EVOLUTION PLANNING

RE: DA2020/1501 – 38 Undercliff Road, Freshwater - Response to request for further information.

We refer to your letter dated 15 January 2021 within which Council has raised a number of matters which require further consideration.

Figure 2: Amended perspective from rear Lane

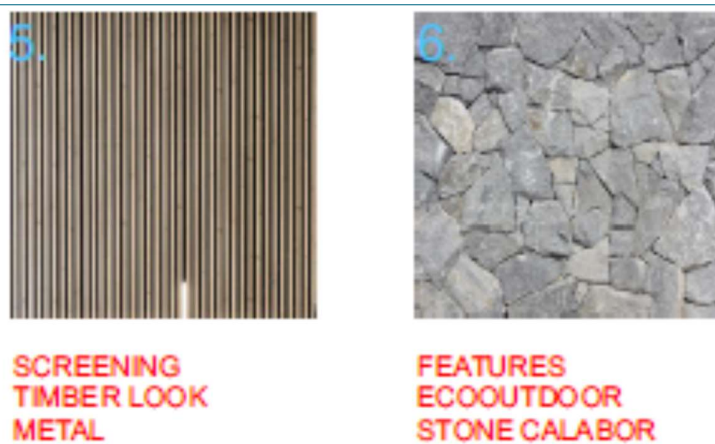
Issue	Response
<p>Setback (Moore Lane) [Rear]</p>	<p>With respect to the rear boundary interface, the design approach has been led by the provision of a double garage (being the preferred location for such structures).</p> <p>The garage is built to the rear boundary, which is not inconsistent with other developments on the Lane. Any setback from the boundary would, in our view, be of limited merit and would instead restrict opportunities for landscaping and recreation space at the heart of the site.</p> <p>Instead of having a vacant portion of land by the provision of side setbacks to the garage, it was decided to make the most efficient use of the land by providing a secondary dwelling which represents a positive outcome in terms of the availability of affordable housing; a positive outcome in terms of securing the site from the rear Lane; and, creates an further space for practically sized private open space above.</p> <p>The rear presentation, (as amended), to the lane is considered to be satisfactorily articulated to minimize the perceived massing of the structure for the following reasons:</p> <ul style="list-style-type: none"> • The rear wall is divided into two distinct parts by the use of different materials, colours and textures, with the garage door being of timber effect metal paneling and the wall of the secondary dwelling being a grey stone finish; • The provision of three windows facing the Lane; • The setting back of the rear edge of the terrace above from the rear edge of the structure to allow for a non-trafficable planter bed allowing for cascading overhanging plants to soften the built form; • The replacement and setting back of the glazed balustrade with a metal blade type balustrade; • Amendments to the privacy screen at the eastern edge of the terrace and setting back the western edge of the terrace as described below. <p>Refer to the figures below showing extracts from the schedule of finishes and the amended perspective from the rear.</p>

- Setback terraced area on top of the garage and secondary dwelling from the rear and western boundaries by ~1m including the introduction of a non-trafficable landscaped planter bed in the recessed area; and, the replacement of the glazed balustrade in this location with a black steel blade type fence;

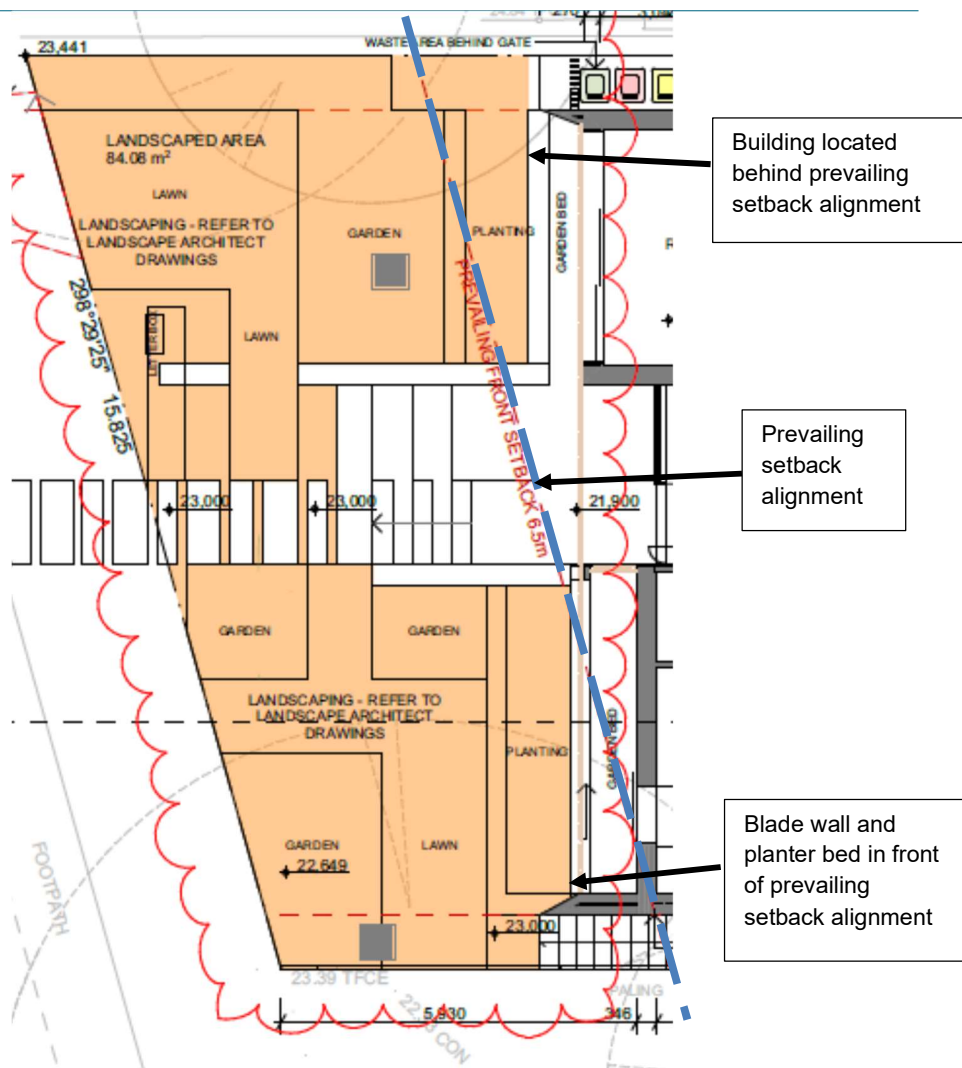
Setback (Undercliff Road) [Front]	<p>When assessed against the prevailing front setback of 6.5m, the proposed development encroaches marginally into the front setback area at the eastern part and sits behind the prevailing building alignment to a greater degree at the western part.</p> <p>The non-compliance at the eastern part comprises a blade framing element of the building which is considered to be essential to the aesthetic and</p>

As a direct response to the matters raised by Council, the reconfigured driveway and hardstand parking area have been removed from the proposal, creating an enhanced streetscape outcome and landscaped character setting, as discussed further below with respect to “*landscaped open space*”.

The non-compliance largely arises as a result of the shape of the site, specifically that the site is a right-angled trapezoid and the front boundary is at a diagonal to the side boundaries. Aligning the front of the building to be parallel with the front boundary would not be consistent with the pattern of development in the locality.

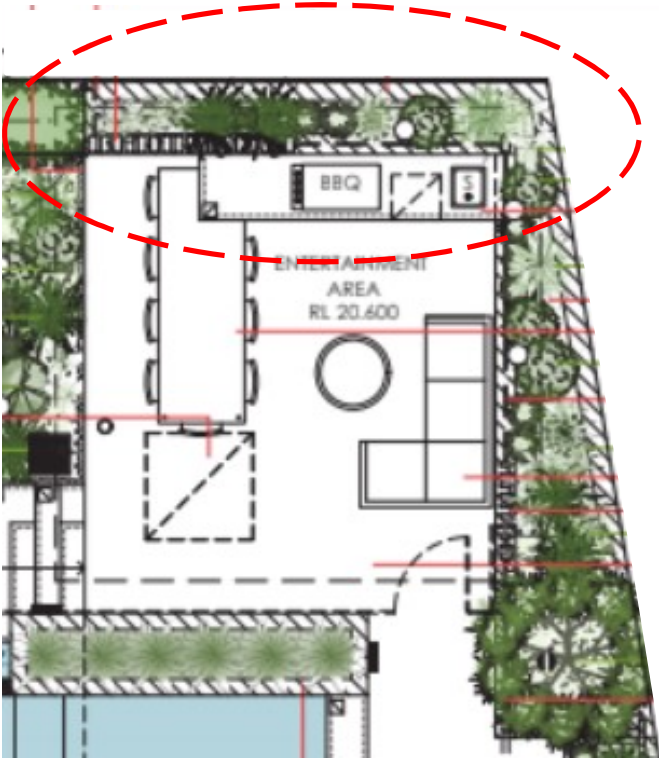
In terms of creating a sense of openness, the minor non-compliance is more than compensated by a larger part of the western part of the building being behind the prevailing building alignment to a greater degree. Refer to the extract below.

Comment: The proposed minor encroachment does not interrupt the visual continuity and pattern of buildings in any significant way particularly since the building to the immediate east is located towards the north of the site and breaks the prevailing alignment and patterns of buildings.
